WCS-CISF-16-005

Enclosure 3

**Changed WCS CISF SAR Pages,
Interim Revision 1**

Figure 1-8
Cask Handling Building Section View

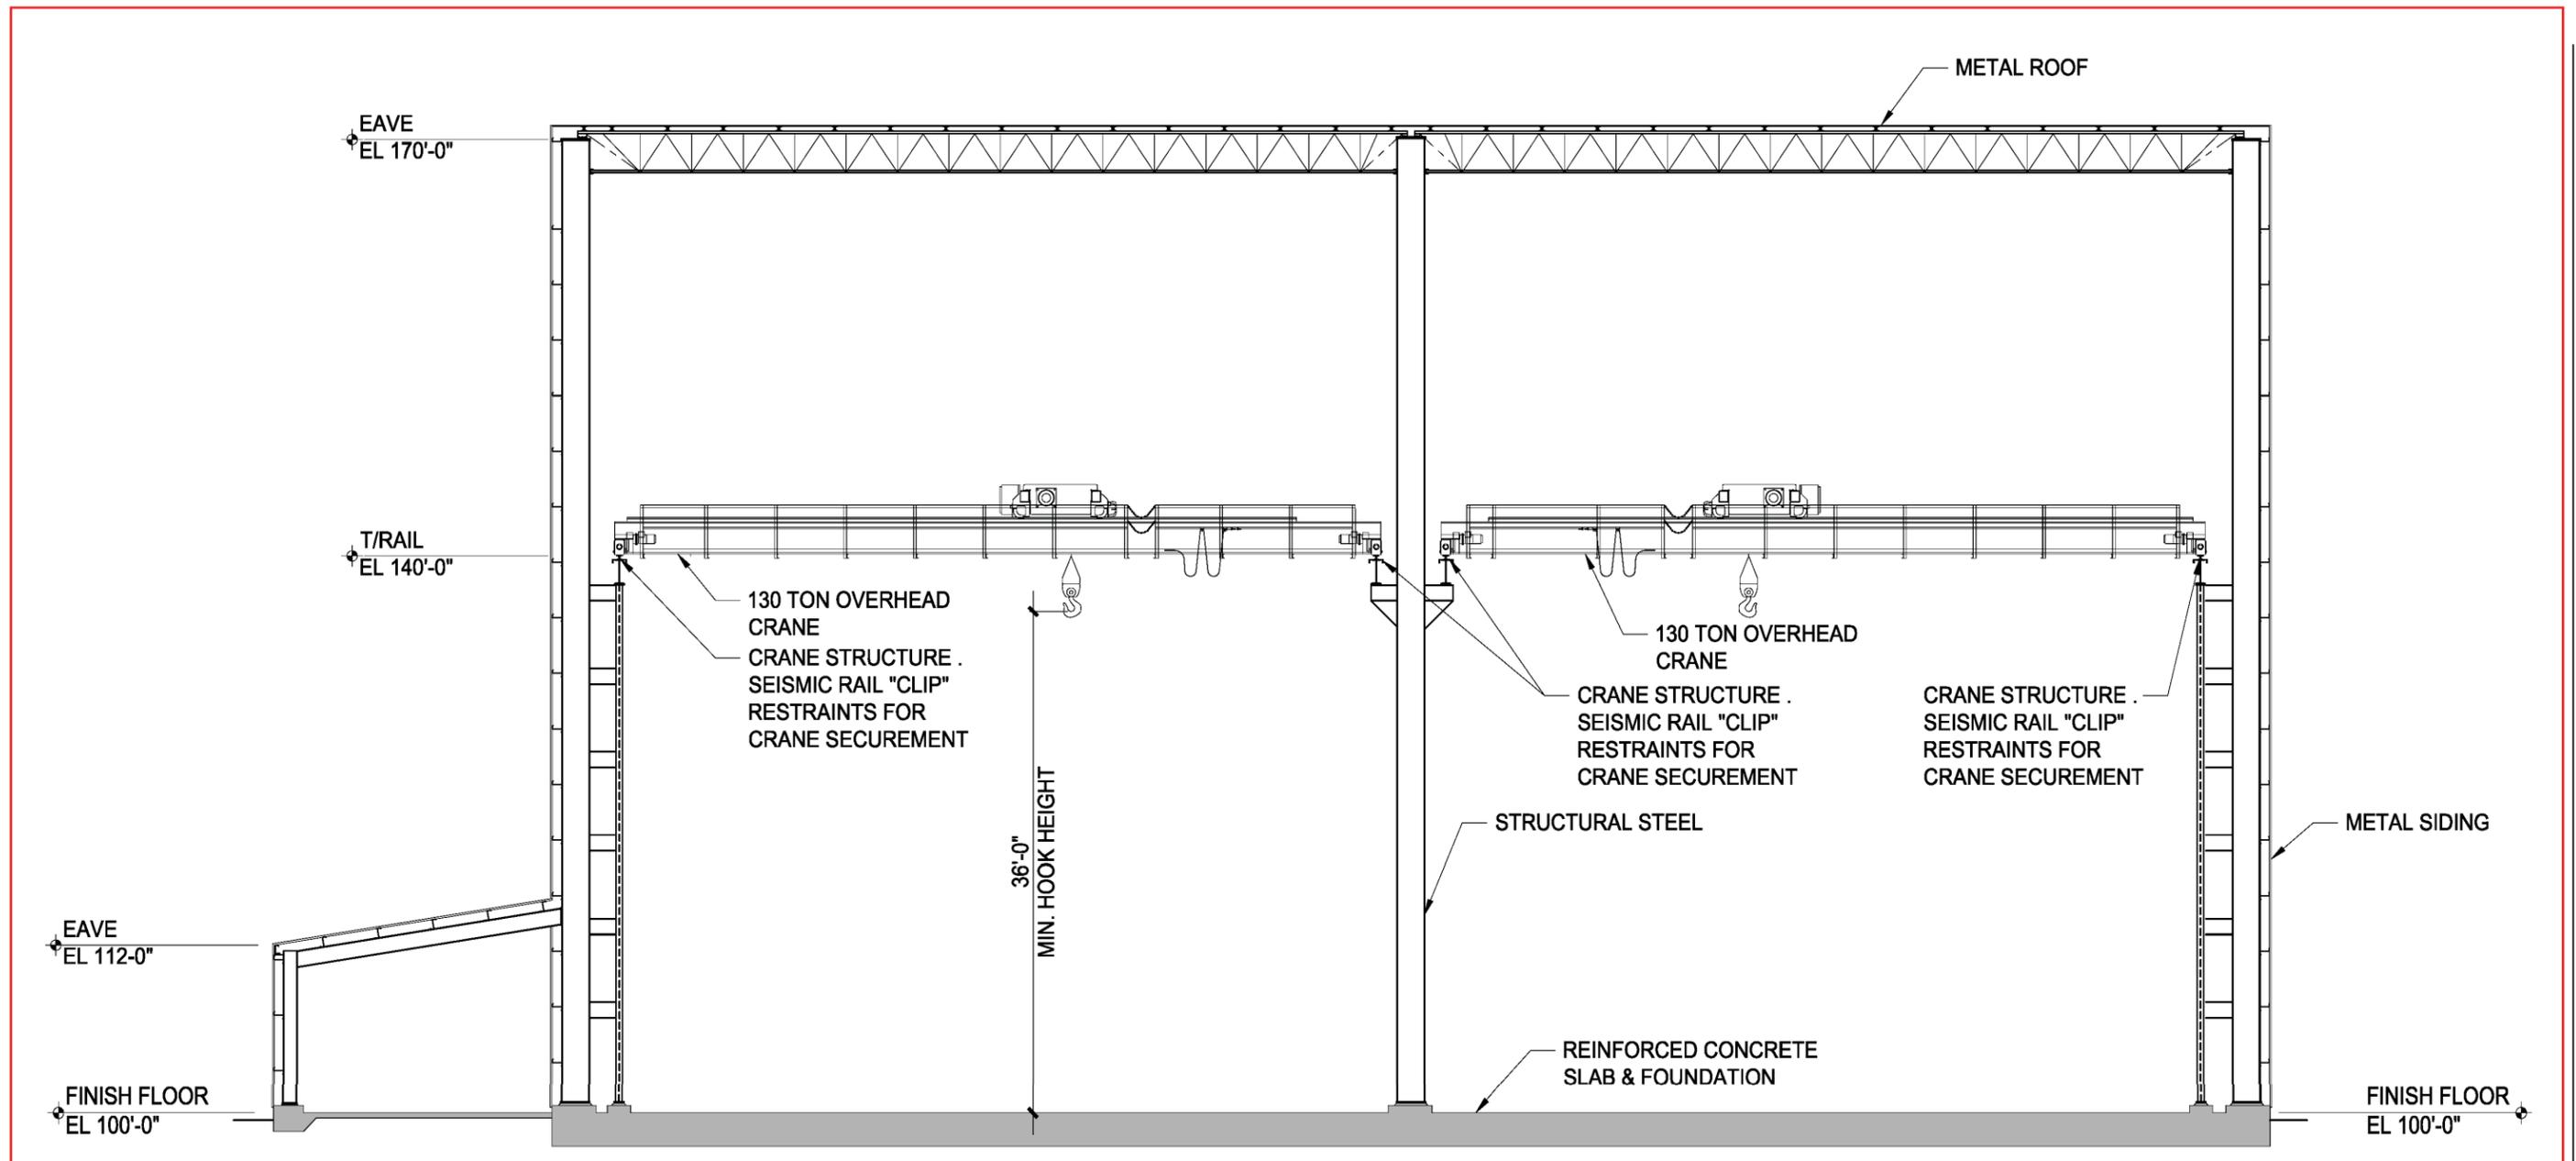
Structural steel beams are provided in the CHB along the crane runways to support the rails for two 130-ton capacity overhead bridge cranes. The steel crane runway support beams are classified as category C Important to Radiological Safety since they provide support for the overhead cranes during a seismic event and prevent the cranes falling onto the transportation cask stations. The steel crane runway support beams are supported on steel columns that are tied to the main structural steel columns of the CHB on one end and steel brackets that protrude from the main structural steel columns of the CHB at the other end. In order to provide lateral support for the steel crane runway support beams, tie members are provided between the steel beams and the CHB frame to resist lateral forces on the steel beams due to crane trolley movement and seismic thrust loads. The steel crane runway support beams are shown in plan on Figure 1-7 and in elevation on Figure 1-8.
